City of Alexandria, Virginia

MEMORANDUM

SUBJECT: 2nd CONCEPT REVIEW WORK SESSION FOR
RECONSTRUCTION AND AN ADDITION TO 0 PRINCE STREET;
THE FORMER BEACHCOMBERS, BAR CASE #2014-00296

Concept #2 Site Plan

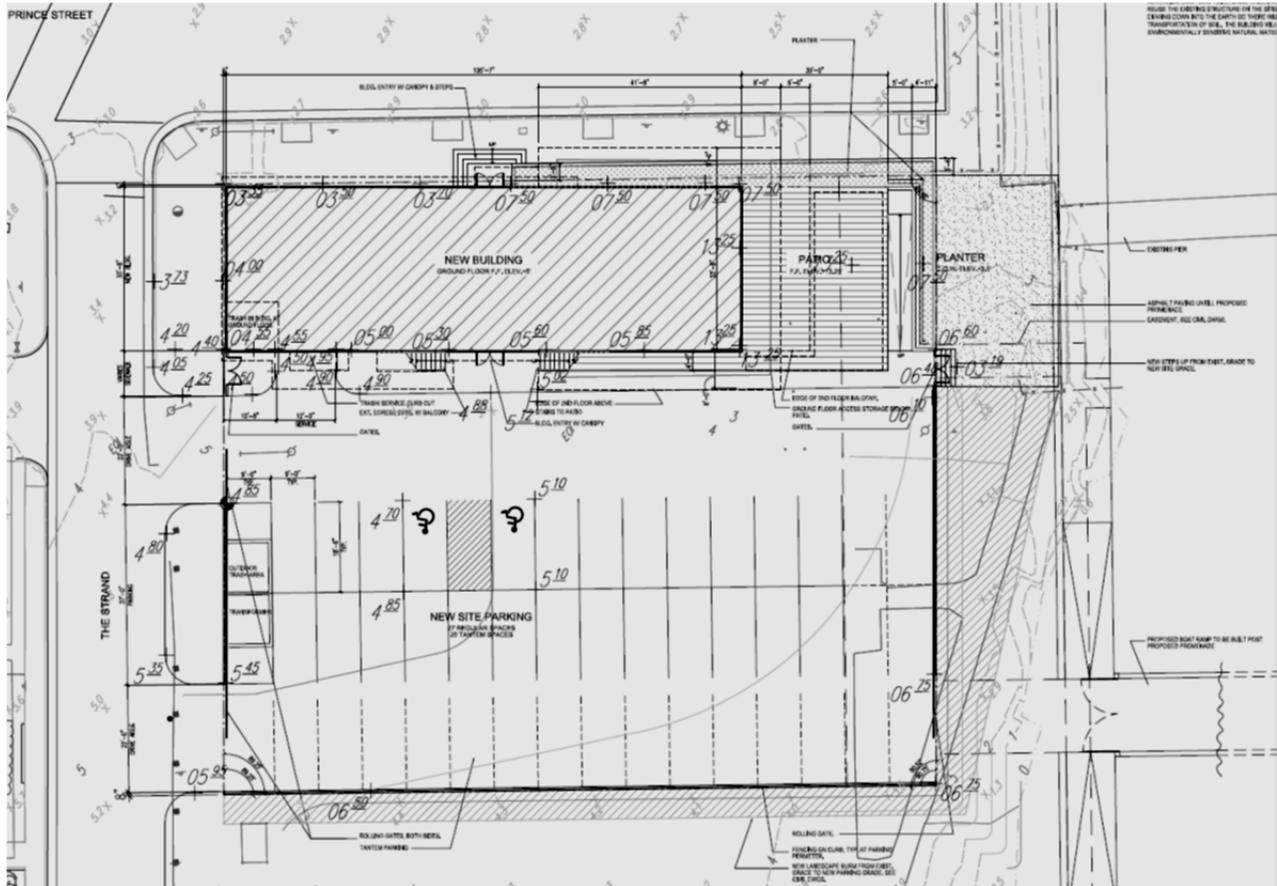
While the focus of the submission was on the architecture, the site plan indicates the construction of fencing around the perimeter of the parking lot with rolling gates along The Strand and the Waterfront and an outdoor trash area and transformer to be installed within the parking lot facing The Strand. Staff supports the applicant's desire to construct a low fence or wall that would provide more visual openness for the pedestrians and those in automobiles, however, staff is concerned about housing trash outside the building, even if it is to be in a very attractive enclosure. The Strand will be a future amenity for residents and minimizing exterior trash receptacles, and their potential odors, in this corridor is desirable. It is also recommended that discussions regarding the location and placement of the transformer be undertaken with Dominion Virginia Power early in the design stage, to determine whether there are other less visible locations for this required facility and Dominion Virginia Power requirements for the transfer location.

- 3) Transformers/enclosures in the parking lot
 - a) Staff request full information from the applicant in terms of the dimensions of the transformers and dimensions and proposed finished materials for the screening. The applicant is advised to determine that the location and size of the transformer as shown is suitable and permissible for Dominion Virginia Power prior to submittal of the Preliminary plan.

- b) Staff does not support any trash enclosure at this location.
- 4) Perimeter Fence
 - a) Staff request full information from the applicant in terms of the dimensions and proposed finished materials for the fences and all associated walls and gates at the full perimeter.

- b) Fence height shall be minimized to the extent possible.
- 5) Storage under the patio
 - a) Staff does not support the recent addition of storage under the patio area. Previous discussion with the applicant's team was that the patio area would be set on solid fill.

SHEET No.
C5.0

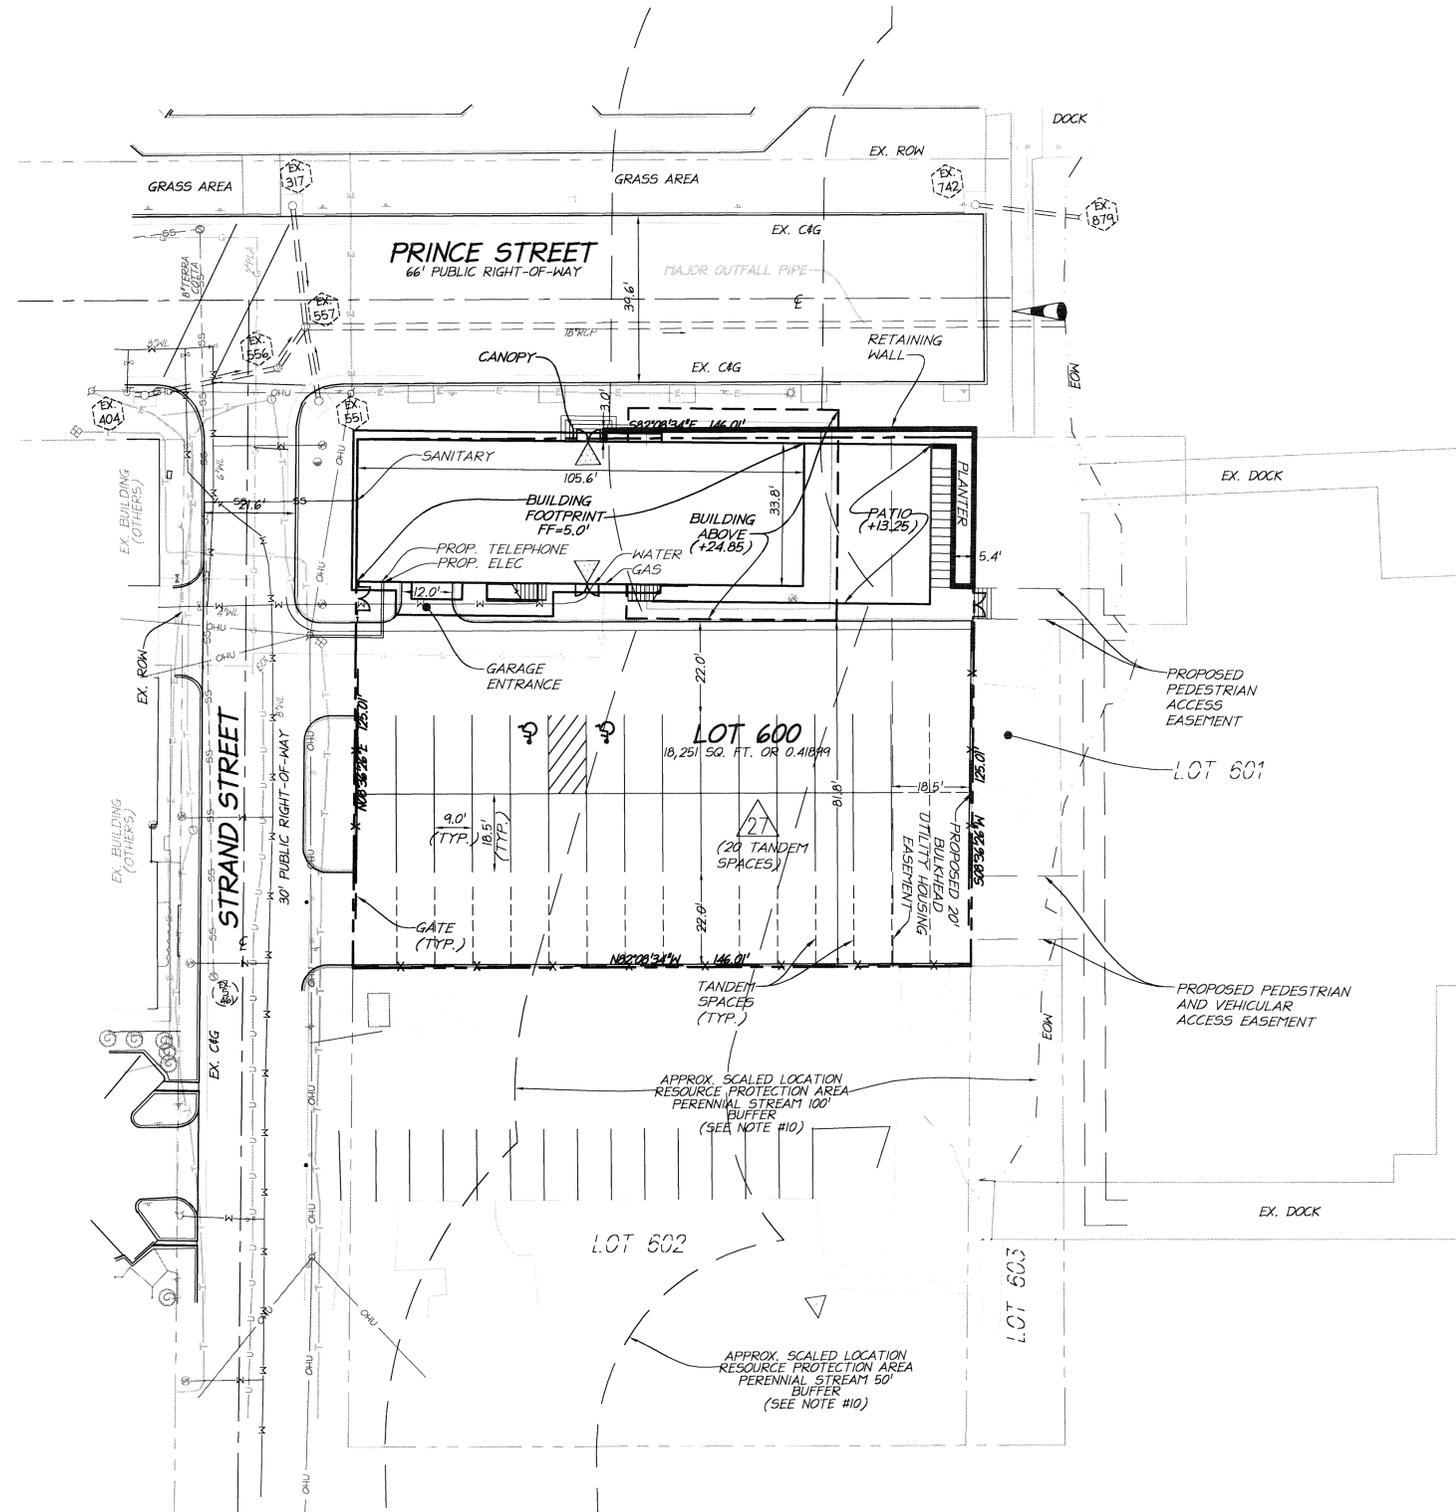
- C-4 Provide all proposed fences and corresponding heights surrounding property.
